STATE OF NORTH CAROLINA
DEPARTMENT OF TRANSPORTATION

SUBJECT: Median U-Turn Bulbs

DATE: February 5, 2009

DIRECTIONAL CROSSOVER WITH MEDIAN U-TURNS

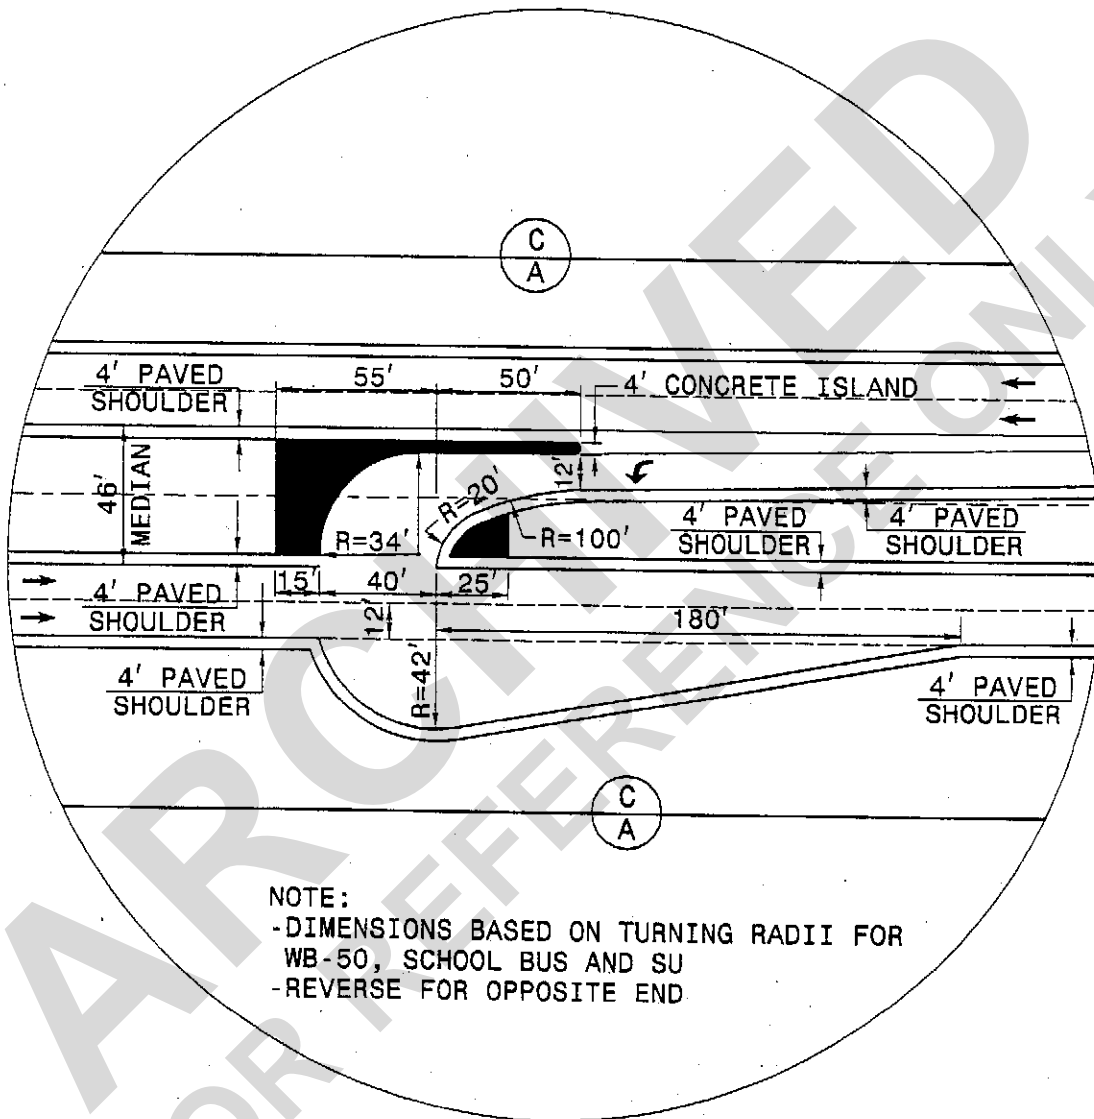
In an effort to reduce right of way impacts and minimize costs, the median U-turn bulb-out design for a 46' median has been revised.

The revised design reduces the bulb radius to 34' and modifies the configuration of the concrete island. A turning vehicle may need to use the 4' paved shoulder to complete the turn. This design will accommodate WB-50 and WB-65 design vehicles.

Plans that will be submitted for right of way acquisition on June 19, 2009, and beyond should incorporate this update. Design changes for other projects will be evaluated on a case-by-case basis. Please discuss the need to incorporate these changes with the Division Construction Engineer or Resident Engineer. If you have any questions regarding this information, please contact Jay A. Bennett, PE at 919-250-4016.
